DOCKET ITEM #13
Resource Protection Area Exception Request
4898 West Braddock Road - Newport Village

Staff Recommendation: DENIAL
Staff Reviewers: Jesse Maines, Stormwater Management Division Chief, T&ES, jesse.maines@alexandria.va.gov Melanie Mason, Principal Planner, T&ES, melanie.mason@alexandriava.gov Maya Contreras, Principal Planner, P&Z, maya.contreras@alexandriava.gov

**Newport Village Resource Protection
Area (RPA) Exception Request
4898 West Braddock Road**

Attachment 8: Concept 2 plan revised

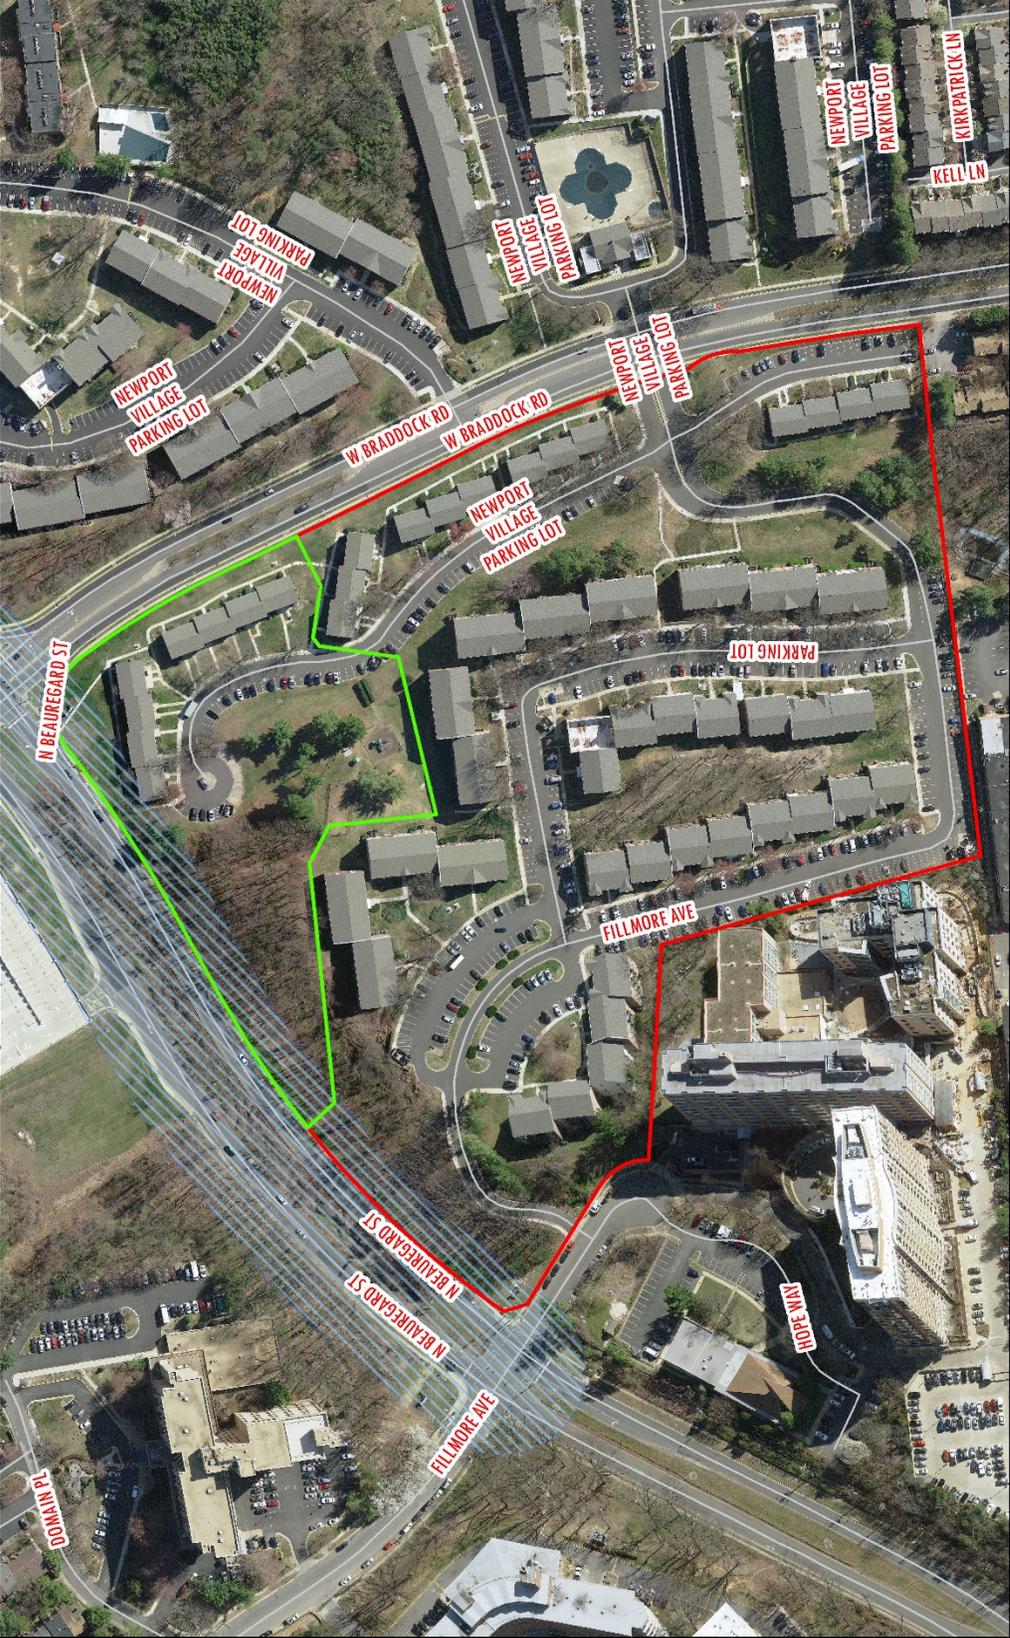
layouts that removed the existing building from the RPA and added no new impervious area to the RPA. The existence of these layouts in previous submissions clearly demonstrates it is possible to develop the site without additional encroachments.

The property owner created the need for the exception by proposing construction within the RPA when there are development options that do not require an encroachment in the RPA. The applicant previously submitted a concept plan to the City with no new encroachments in the RPA clearly demonstrating the proposed layout associated with this request is self-created.

MITIGATION PLAN

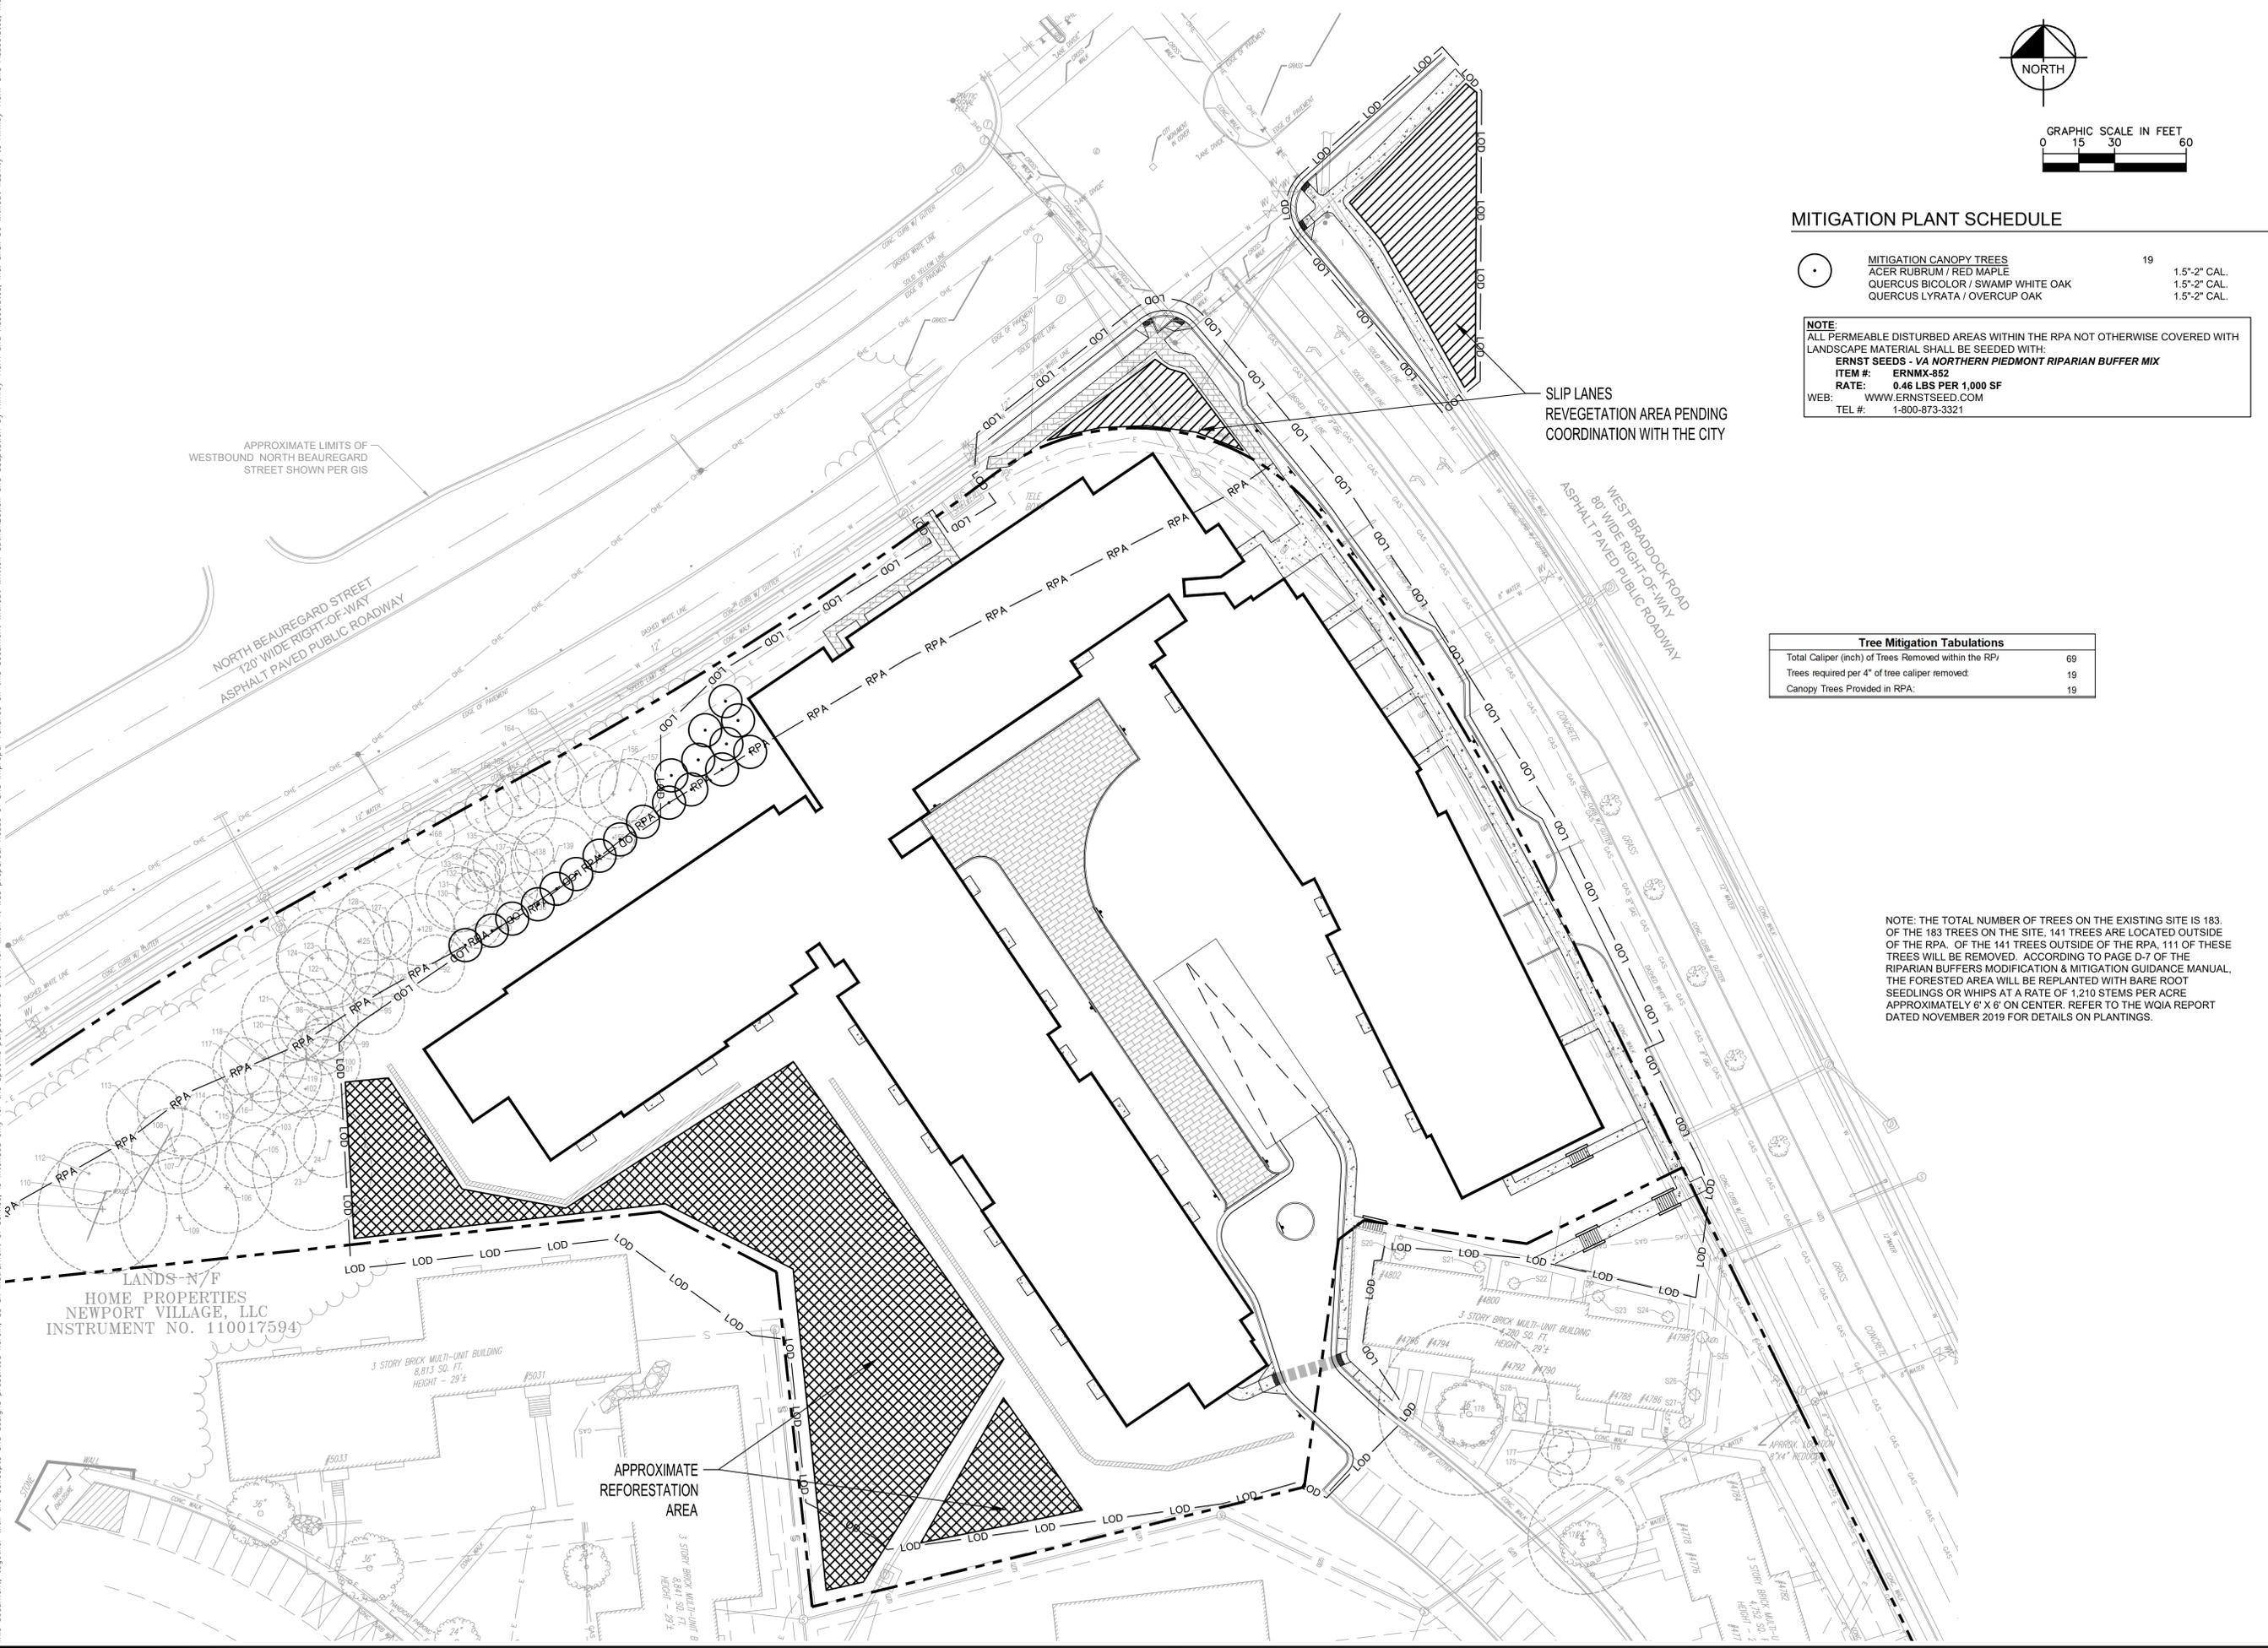
The proposed reforestation does not consider that the project proposes to remove 118 of 183 existing mature trees currently on the site. The area proposed for reforestation would be planted with seedlings, many of which will not survive, and is much further away from the RPA than the mature trees that would be removed if this exception is granted with the development. The phosphorous removal gained from any replanting will be negated by the additional phosphorous generated by the loss of 118 mature trees on the site.

Finally, the applicant has included the removal of slip lanes at West Braddock Road and N. Beauregard as mitigation for the proposed RPA encroachment. However, T&ES Transportation Planning staff intends to require the removal of the slip lanes for traffic planning purposes regardless of whether the RPA encroachment is approved. There is no additional benefit beyond what would be proposed without the encroachment for the loss of the slip lanes.

The proposed mitigation options do not negate the permanent loss of additional buffer area in the RPA and the introduction of new impervious surface that would negatively impact water quality. The adjacent perennial stream is not suitable for stream restoration, the reforestation does not add additional benefit beyond mitigating what will be lost from the removal of the existing mature trees, the pet waste plan is not a valid buffer mitigation option, and the slip lanes will be required to be removed even if the encroachment is denied.
